# UNITED STATES PATENT AND TRADEMARK OFFICE

10/725,623

Michael M. Kamrava

<b>Office Action Summary</b>	<b>Application No.</b> 10/725,623	<b>Applicant(s)</b> KAMRAVA, MICHAEL M.	
	<b>Examiner</b> Camtu T. Nguyen	<b>Art Unit</b> 3772

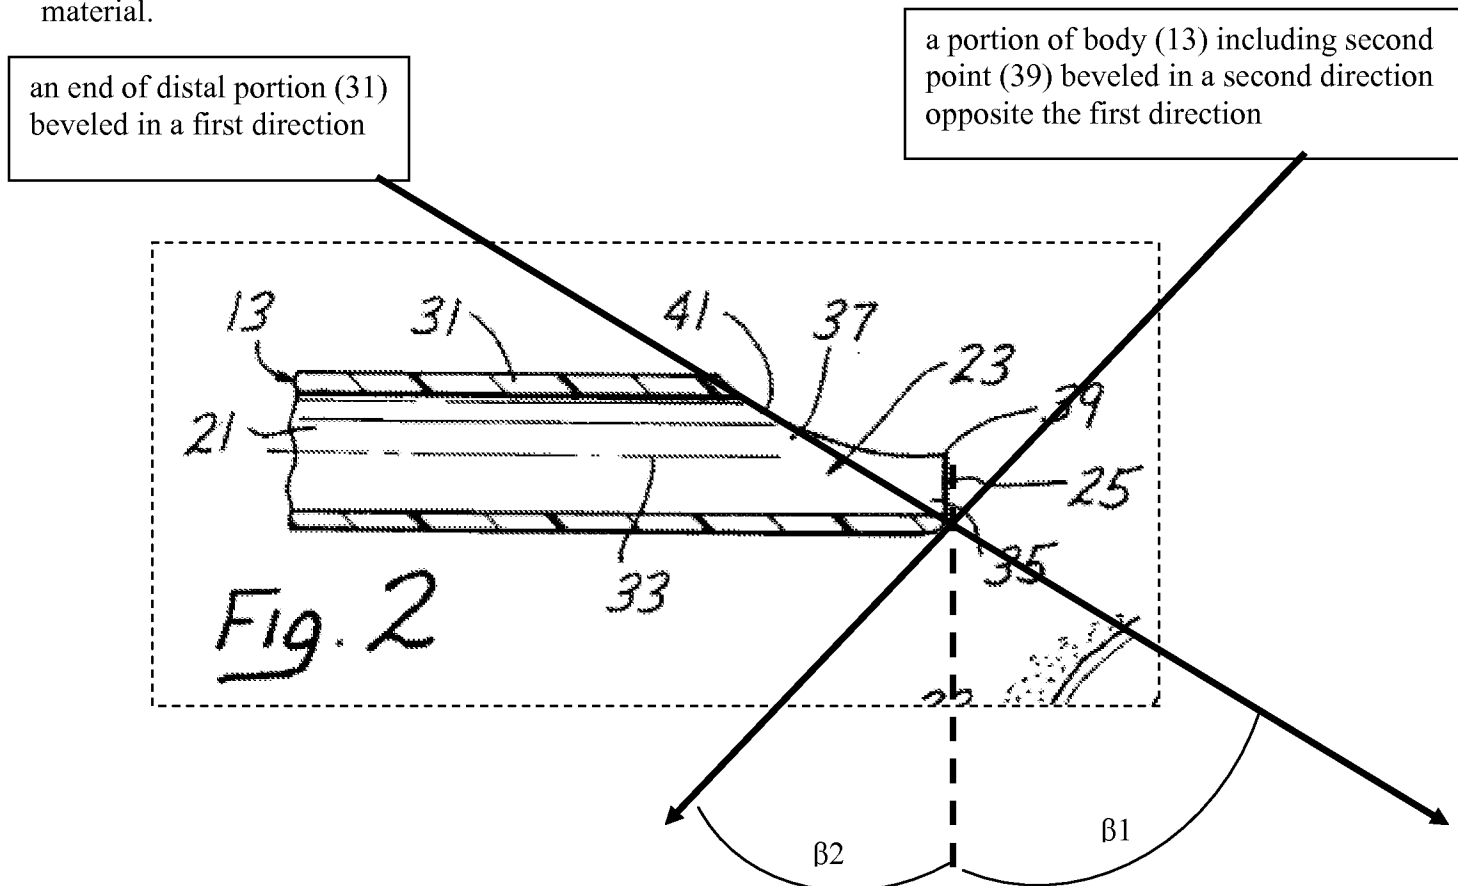
Claims 1-18 are rejected under 35 U.S.C. 103(a) as being unpatentable over by (U.S. Patent No. 4,474,576) and further in view of Bacich (U.S. Patent No. 5,472,419). Gobby discloses an artificial insemination a delivery member (30) comprising a delivery section (51), a storage section (53), and a passage through both sections (51, 53), the delivery member (30) defines a first axis of symmetry throughout the passage. Figure 2 illustrating a distal portion of the delivery member (30) is offset so as to preferably between 2 to 5 degrees inclined to the

longitudinal axis of the delivery member (30), thus, the distal portion of the distal delivery section (31) defines a second different axis of symmetry throughout the passage a first axis of symmetry. The Gobby device does not disclose the distal passage portion of the delivery section (51) is beveled. Bacich discloses a transfer catheter body (13) comprising a proximal portion (27), a distal portion (31), an elongated passage (21), the distal portion (31) having an end that is beveled in a first direction across the passage (21), a portion of catheter (13) including a second point (39) is beveled in a second direction opposite the first direction defining a tip, showing by  $\beta 1$  &  $\beta 2$  below. Therefore, it would have been obvious to one skilled in the art during the time of this invention to modify the Gobby's distal passage portion of the delivery section (51) such that it would beveled, taught by Bacich, as such would not only facilitate the delivery process but also serve as a tool cutting through the endometrial lining when delivering the productive material.

Regarding claims 2 & 3 and 14 & 15, particularly to claims 3 & 15 reciting the beveled opening angled between 10° to 15°, Figure 2 illustrates such opening angle range.
